APPLICATION NO.	FILING DATE	FIRST NAMED INVENTOR	ATTORNEY DOCKET NO.	CONFIRMATION NO.
10/752,208	01/06/2004	Irving Sabo	2258.002	2638
23405	7590	01/04/2006		
HESLIN ROTHENBERG FARLEY & MESITI PC 5 COLUMBIA CIRCLE ALBANY, NY 12203			EXAMINER GABLER, PHILIP FRANCIS	
			ART UNIT	PAPER NUMBER
			3637

Office Action Summary	Application No. 10/752,208	Applicant(s) SABO ET AL.	
	Examiner Philip Gabler	Art Unit 3637

DETAILED ACTION

Exhibit 1: Brown '114 Figures 1 and 2

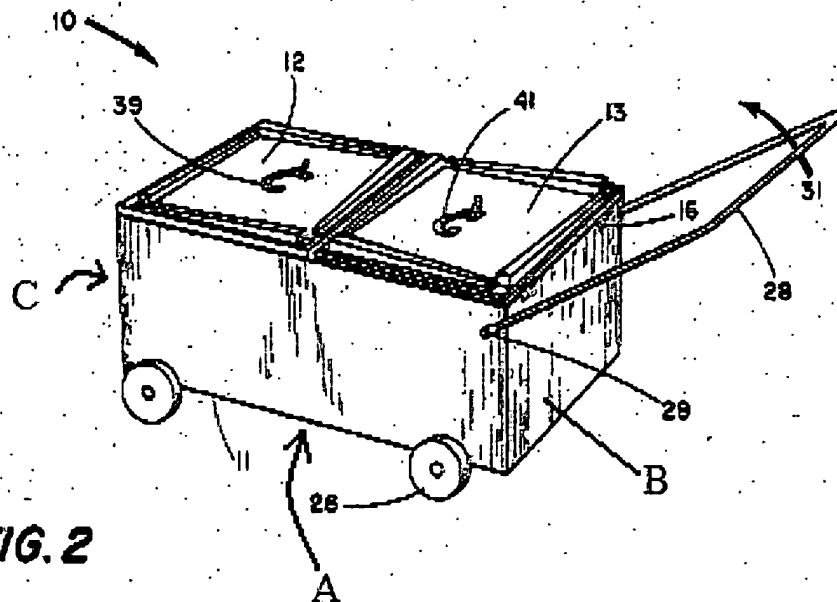
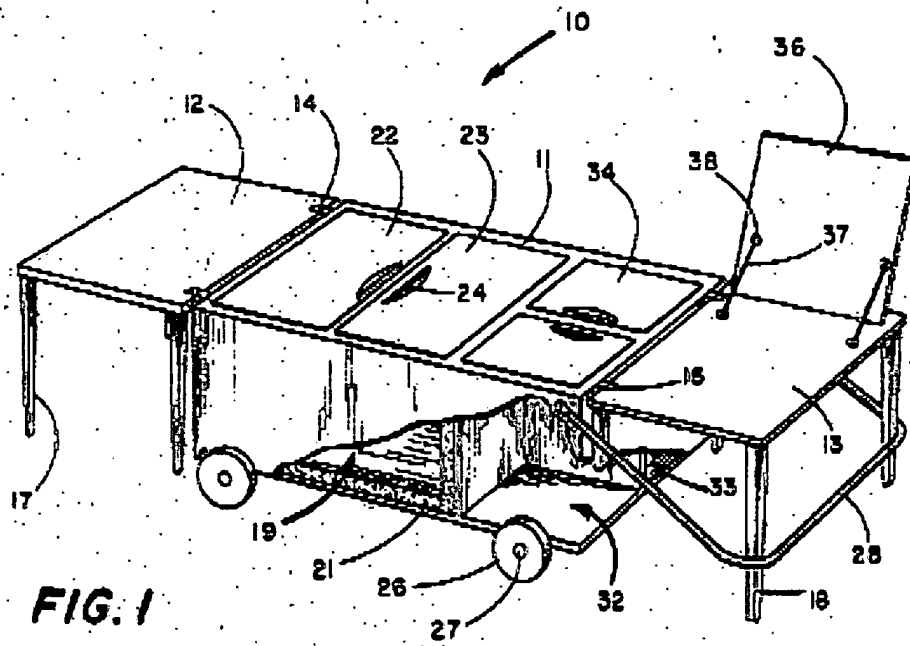
7. Claims 1-10 are rejected under 35 U.S.C. 102(b) as being anticipated by Brown (US Patent Number 3873114). Brown (Figures 1 and 2) discloses a storage container comprising: an enclosure (11) having an open top (covered in Brown's figures), a bottom (viewed as A in Exhibit 1), a first end (B), and a second end (C) opposite the first end; a first lid (13) pivotally mounted to the first end, the first lid adapted to cover at least some of the open top; and at least one second lid (23) detachably mounted (as evident by the handle for allowing manipulation of the lid to gain access to the container) between the first end and the second end, the second lid adapted to cover at least some of the open top. Regarding claim 2, Brown further discloses a third lid (12) pivotally mounted to the second end (C), the third lid adapted to cover at least some of the open top. Regarding claim 3, Brown further discloses a first end comprising a first end panel (also viewed as B) and wherein the first lid is pivotally mounted to the first end panel. Regarding claim 4, Brown discloses the first end comprising the first end panel (B as noted above) and the second end comprising the second end panel (C as noted above), and wherein the first lid is pivotally mounted to the first end panel and the third lid is pivotally mounted to the second end panel. Regarding claim 5, Brown further discloses a first lid adaptable to be pivotally mounted into a horizontal position outside

the open top of the enclosure (see Brown's Figure 1). Regarding claim 6, Brown further discloses at least one of the first lid and third lid are adapted to be pivotally mounted into a horizontal position outside the open top of the enclosure (see Brown's Figure 1). Regarding claim 7, Brown further discloses the first lid is adapted to be pivotally mounted in a vertical position outside the open top of the enclosure (not only does the lid swing through a first vertical position between its closed and open horizontal positions, but, with the legs folded, it could continue to a second, downward, vertical position along the end of the container). Regarding claim 8, Brown further discloses the first lid, the second lid, and the third lid are adapted to substantially enclose the open top of the enclosure. Regarding claim 9, Brown further discloses at least one removable sub-container (19) positioned within the enclosure. Regarding claim 10, Brown further discloses a plurality of detachably mounted second lids (22), (23), (34).

Primas '399 Figures 9, 11, and 12

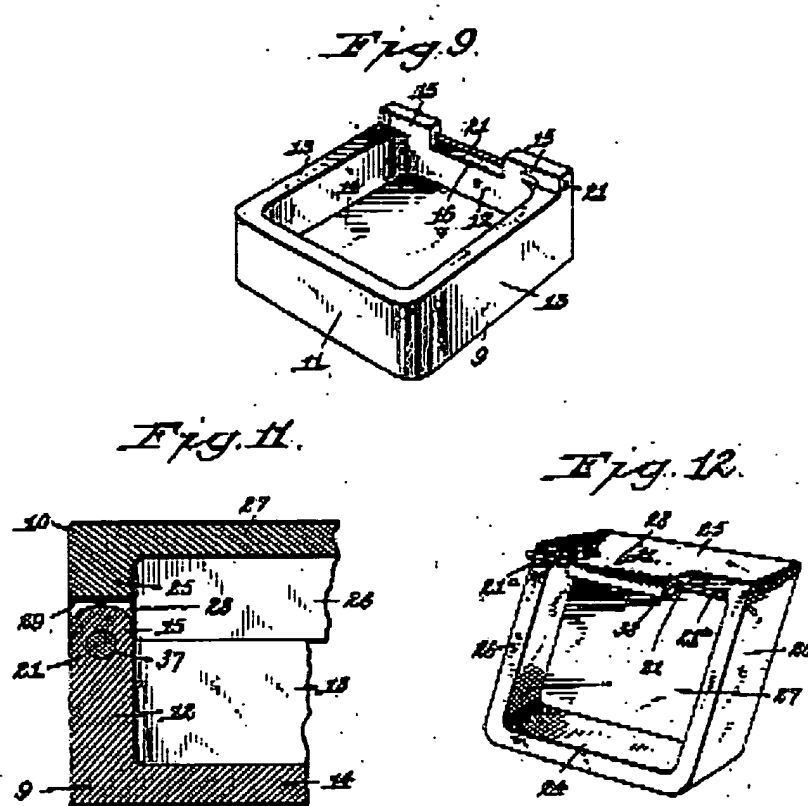
9. Claims 21-30 are rejected under 35 U.S.C. 103(a) as being unpatentable over Brown in view of Primas (US Patent Number 2200399). Brown discloses a hinge assembly (16) for use with a storage container having a lid and an end panel wherein the hinge assembly is adapted to allow rotation of the lid about an axis. Brown does not disclose a lid having a through hole, a hinge block having a through hole or a circular rod. Primas (Figures 9, 11, and 12) discloses a container with a lid (10) with a through hole (38) pivotally mounted to a housing (9) by a hinge assembly comprising: at least one hinge block (15) having a through hole (37); and a circular rod (21) adapted to engage the through hole in the block and lid, the circular rod having an axis (along length of 21); wherein the hinge assembly is adapted to allow rotation of the lid about the axis of the circular rod. Accordingly, it would have been obvious to one of ordinary skill in the art at the time the invention was made to modify Brown's hinge assembly as taught by Primas to use a lid and a hinge block with a through hole connected by a circular rod because this would provide a sturdy, simple hinge design.

11. Regarding claims 29 and 30, Brown, when modified by Primas as described above, discloses a storage container as recited in claim 21. Primas further discloses a hinge assembly wherein the at least one hinge block comprises at least two hinge blocks (two features 15) and a container lid comprising at least one notch (the gaps on either side of 28) wherein the at least one hinge block is adapted to engage the at least one notch. Accordingly, it would have been obvious to one of ordinary skill in the art at the time the invention was made to further modify Brown's hinge assembly as taught by Primas to use a hinge assembly with at least two hinge blocks and a lid with notches to engage these hinge blocks because this arrangement would provide Brown's container with an effective hinge design that remains simple to manufacture.
